**UNITED STATES DEPARTMENT OF COMMERCE  
Patent and Trademark Office**

# Office Action Summary

Application No.  
**09/476,521**

Examiner  
**Vinh Luong**

Fig. 1

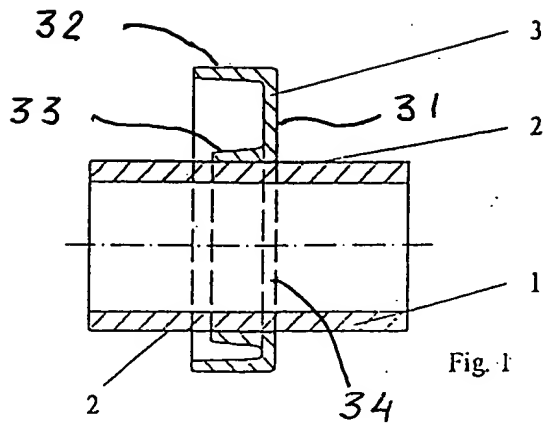
(C) The corrected Fig. 1 has been approved.

8. The original drawings are objected to because: (a) the drawings should show the plane upon which a sectional view such as Fig. 1 is taken; and (b) each part of the invention such as the outer diameter of the end piece should be designated by a referential numeral or character. Correction is required.

Fig. 2

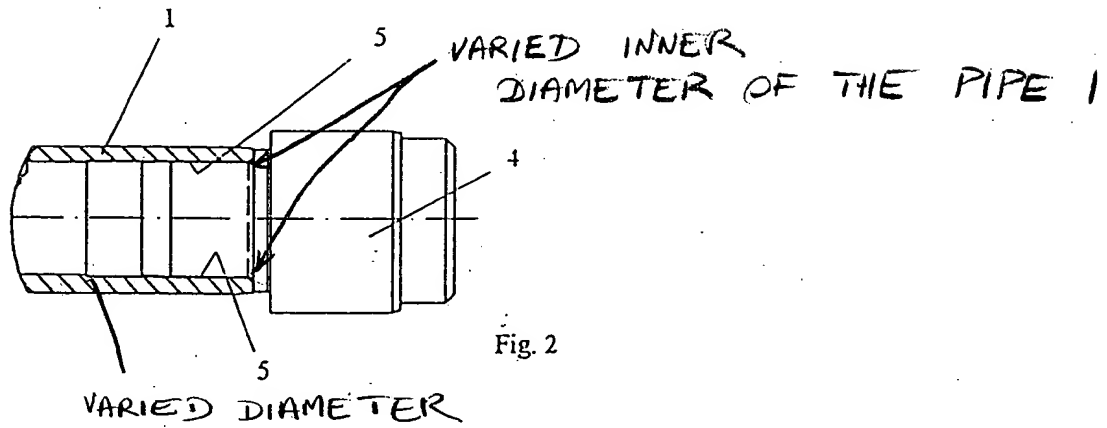
(a) new Fig. 4 introduces new matter such as the end piece 4 as now shown. The original Fig. 2 shows that the inner diameter of the pipe 1 is varied: (1) at the junction of the end piece 4 and the pipe 1 as shown by applicant's phantom line; and (2) at referential numeral 1 (see attached Exhibit). However, Fig. 4 shows that the inner diameter of the pipe 1 is constant. The original disclosure does not convey the concept that the inner diameter of the pipe 1 is constant, thus, it is unsupported by the record as filed. *In re Anderson*, 176 U.S.P.Q. 331 (CCPA 1973); and

Not  
Approved  
VL  
10/20/00

Fig. 3

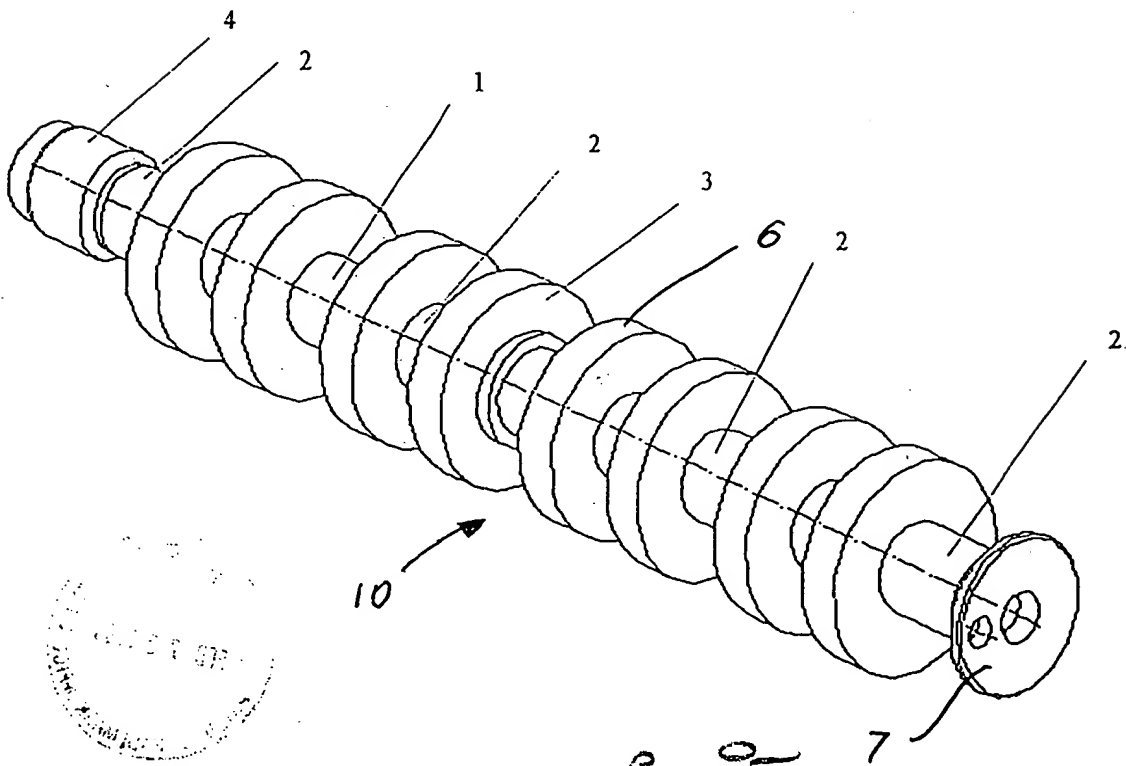
(B) The corrected Fig. 3 has been disapproved since it introduces new matter. The original drawings do not show the bearing rings. The corrected Fig. 3 now shows the bearing 6 which is identical to the cam 3. The showing and description of a specific type of bearing within a full spectrum of possible bearings is considered under the present disclosure to be new matter. *Cf., In re Smith*, 173 U.S.P.Q. 679 (CCPA 1972) and *Ex parte George*, 230 U.S.P.Q. 575, 578 (Bd. Pat. App. & Inter. 1986).

(C) the insertions in lines 13 and 14 on page 6 of the specification. The original drawings do not show the bearing rings. The corrected Fig. 3 now shows the bearing 6 which is identical to the cam 3. The showing and description of a specific type of bearing within a full spectrum of possible bearings is considered under the present disclosure to be new matter. *Cf., In re Smith*, 173 U.S.P.Q. 679 (CCPA 1972) and *Ex parte George*, 230 U.S.P.Q. 575, 578 (Bd. Pat. App. & Inter. 1986).

Fig. 4

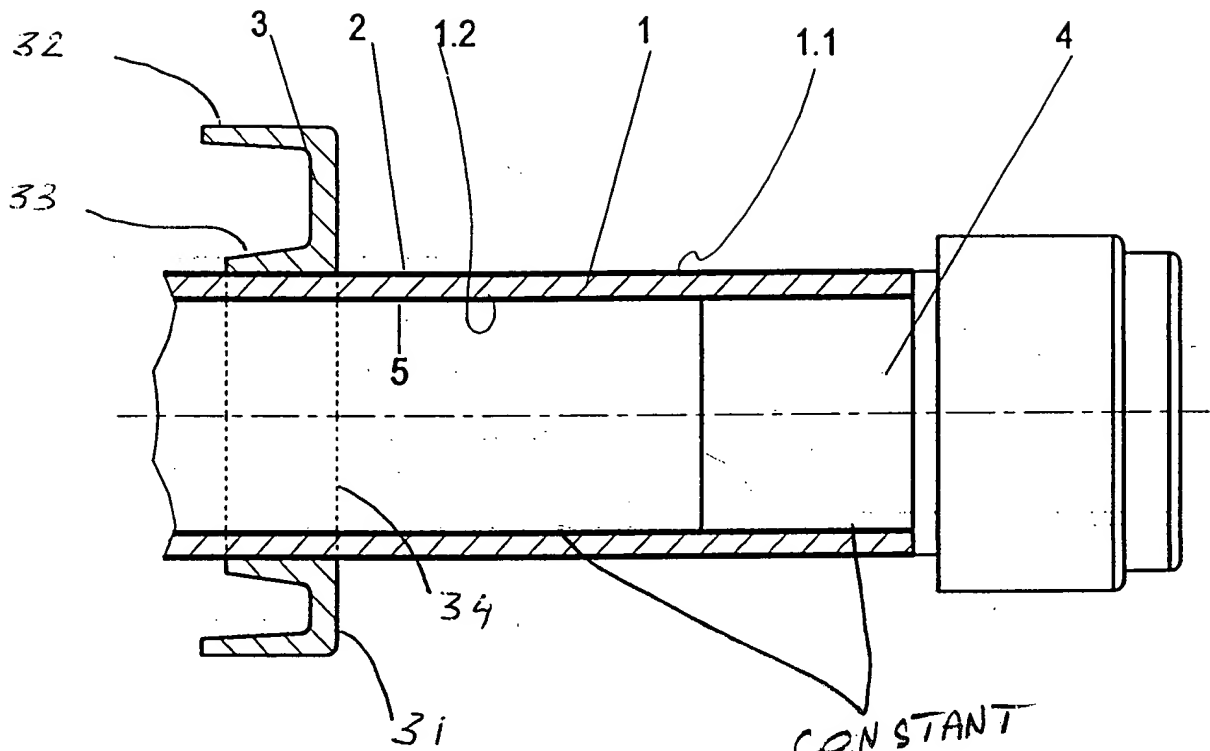
(A) New Fig. 4 has been disapproved because:

(b) new Fig. 4 is inconsistent with the description in Paper No. 9. The insertion on page 6, line 12 of the specification, states that the outer diameter of the end piece 4 is slightly larger than an inner diameter of the pipe 1. However, Fig. 4 shows that the outer diameter of the end piece 4 is equal to an inner diameter of the pipe 1.

Disapproved  
VL  
10/20/00

CONSTANT  
DIAMETER  
(NEW MATTER)
